MIL-C-16173D
AMENDMENT-2
19 November 1968
SUPERSEDING 1/
AMENDMENT-1
17 March 1967

CORROSION PREVENTIVE COMPOUND,
SOLVENT CUTBACK, COLD-APPLICATION

This amendment forms a part of Military Specification MIL-C-16173D, dated 20 October 1966, and is mandatory for use by all Departments and Agencies of the Department of Defense.

Figure 8 - Hot water - low pressure steam removability apparatus.

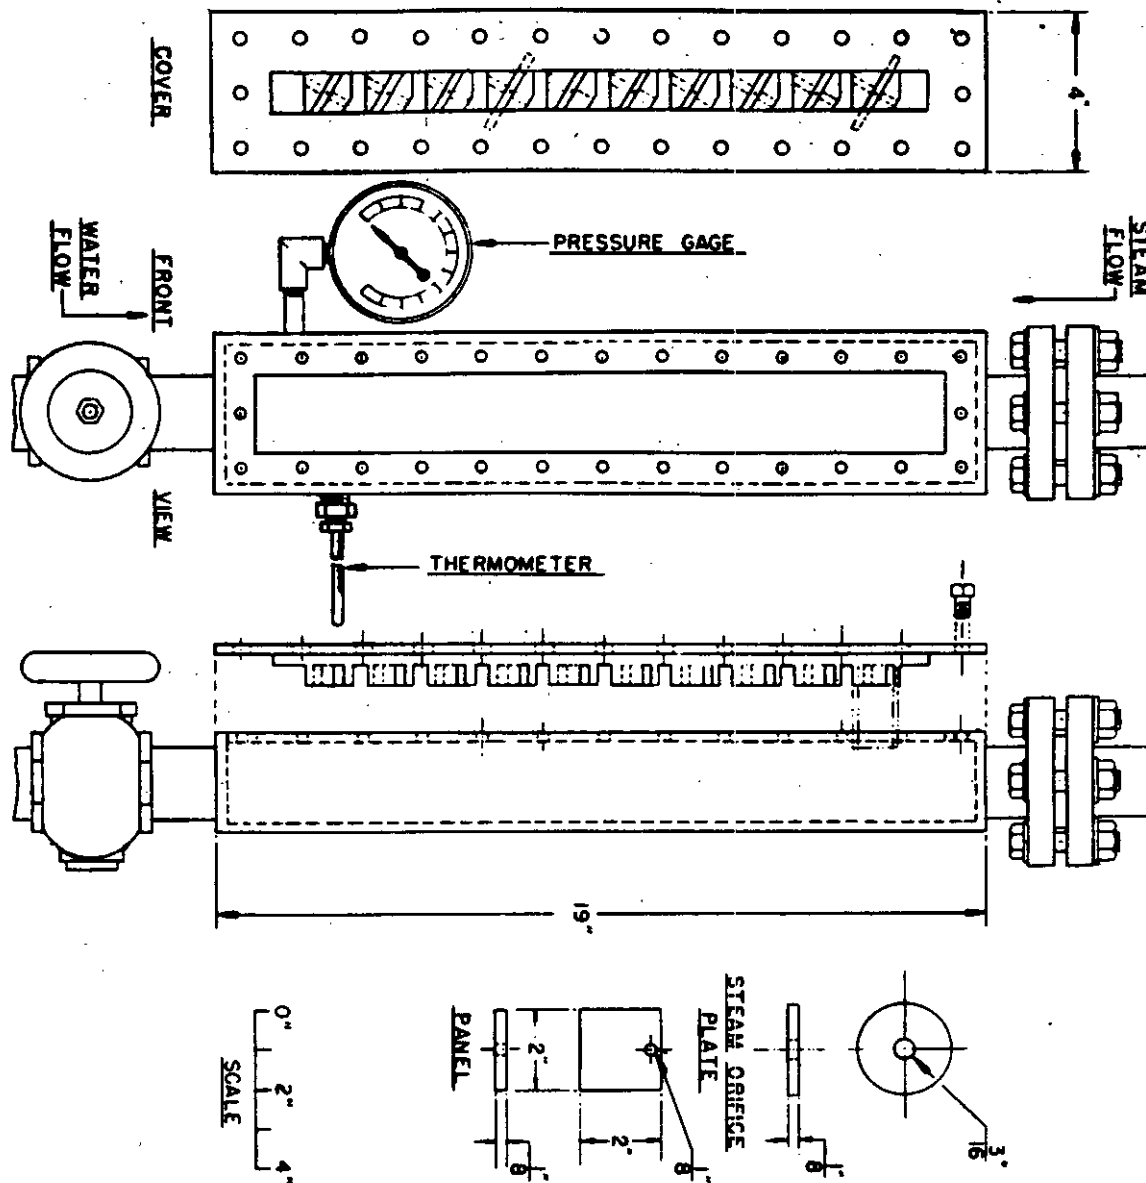
Add the attached figure 8.
